JUNEAU DOUGLAS CITY MUSEUM HVAC UPGRADES Contract No. E14-194

ADDENDUM NO.: TWO

DATE ADDENDUM ISSUED: February 14, 2014

Juneau Douglas City Museum
 Basement: Moving and Handling

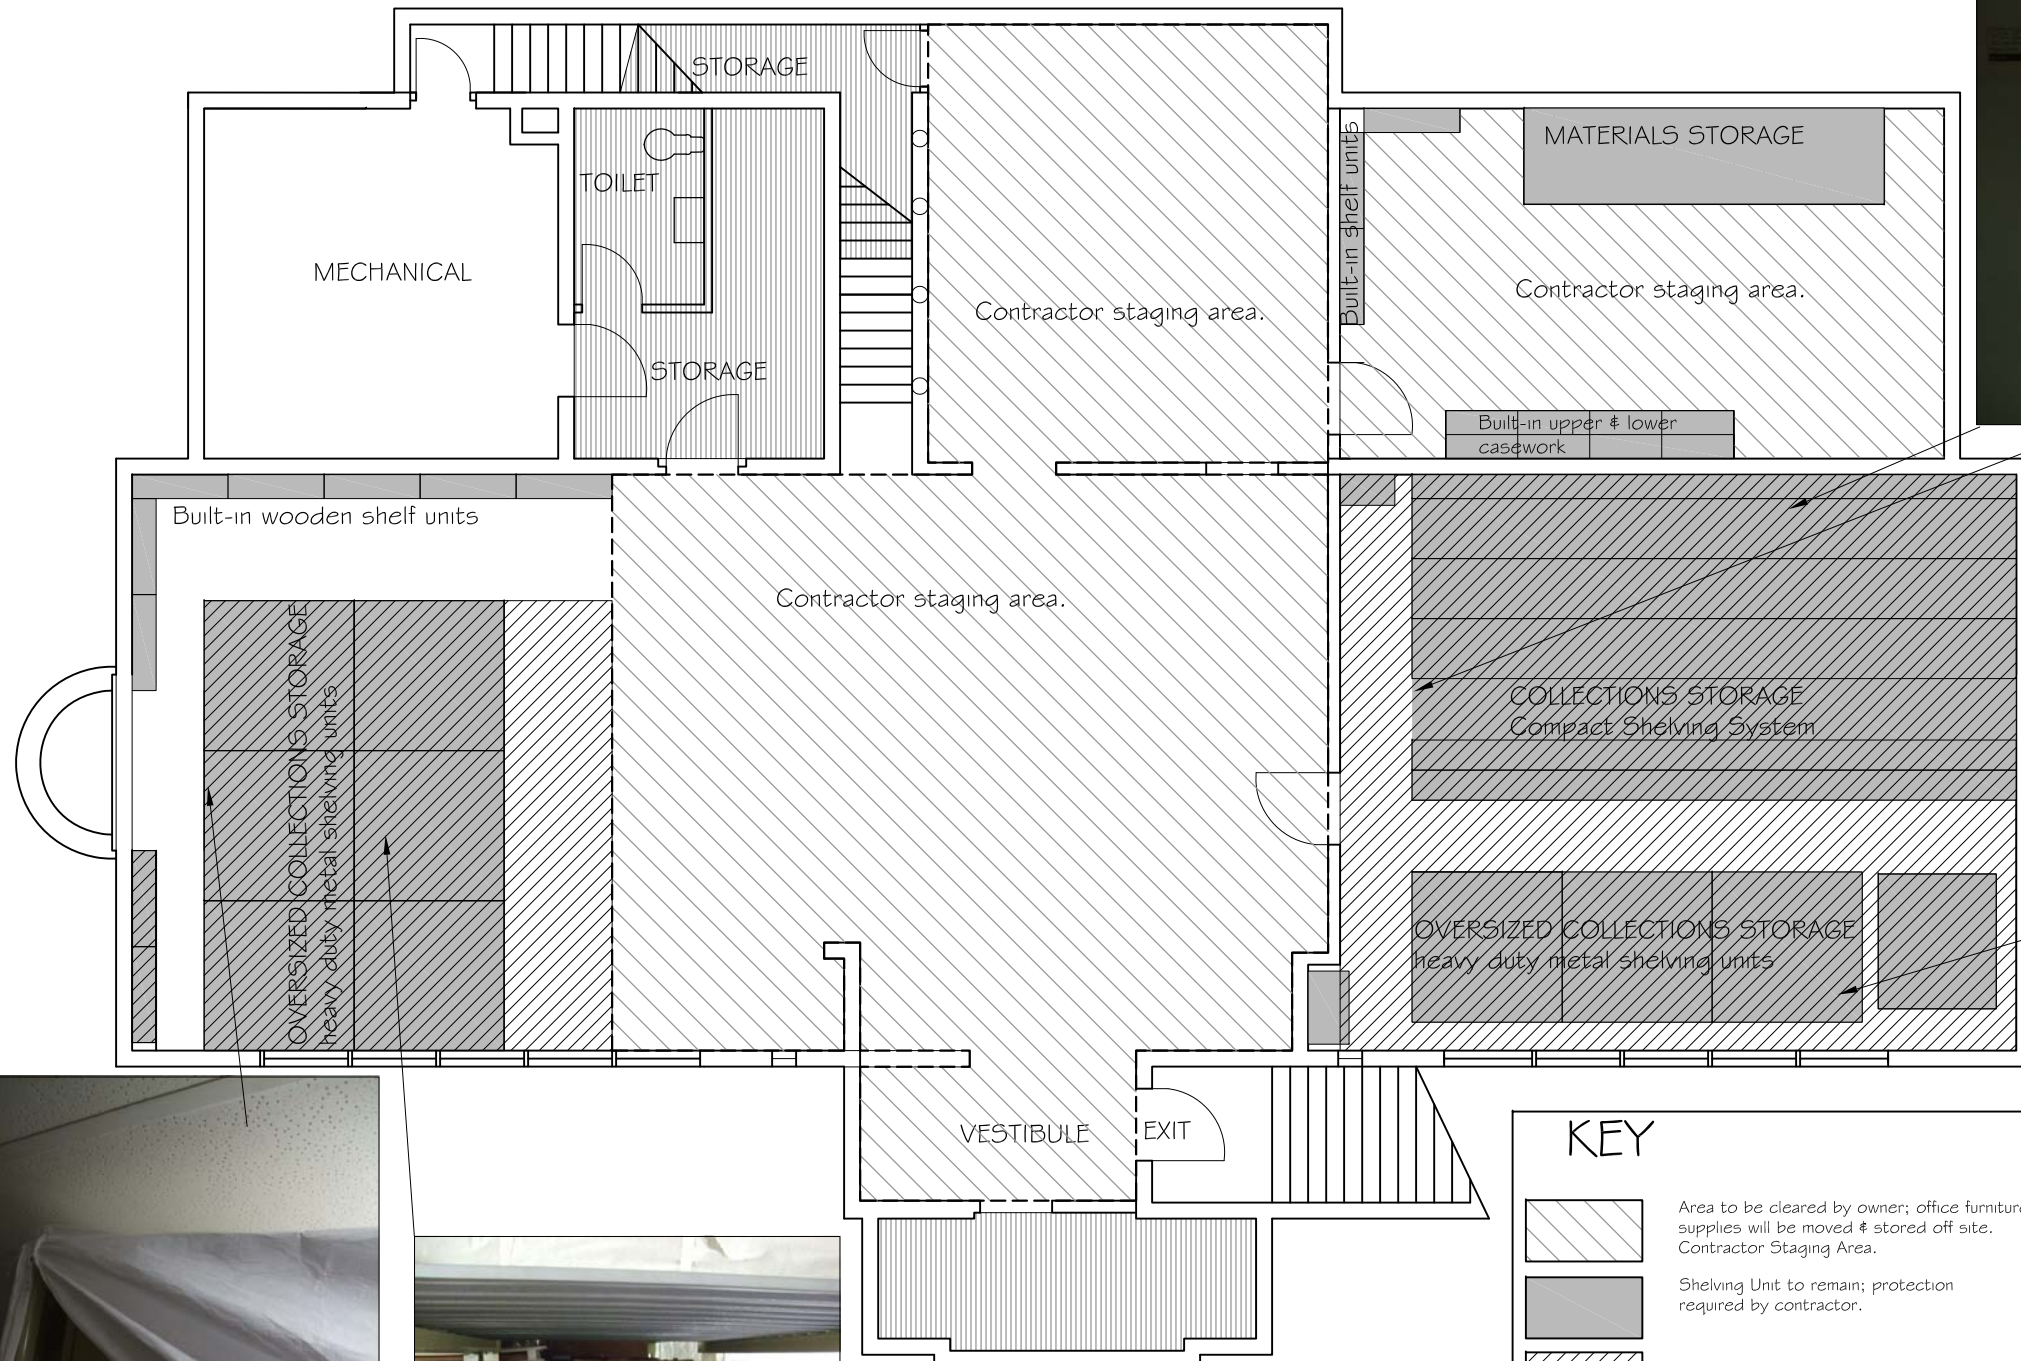
- “2. CONTRACTOR will submit a preliminary abatement plan as part of ‘Plan of Operation’ during the Pre-Construction Meeting.
 - a. Basement storage of collections and artifacts are to remain with existing shelving storage systems and are to be protected by CONTRACTOR. (See Drawing No. 1 of 1 – BASEMENT: MOVING AND HANDLING, labeled Addendum No. 2.)

- b. OWNER will be responsible for the temporary relocation and off-site storage of office furniture shelving and supplies in three areas of basement. These areas will be completely cleared and made available for CONTRACTOR staging area. OWNER requires no less than 10 working days to complete the task. (See Drawing No. 1 of 1 – BASEMENT: MOVING AND HANDLING, labeled Addendum No. 2.)”

“WINDOW REMOVAL IS PART OF ALTERNATE 1.”
- Item No. 8 *Add* Drawing 1 of 1 – Basement: Moving and Handling, labeled Addendum No. 2.
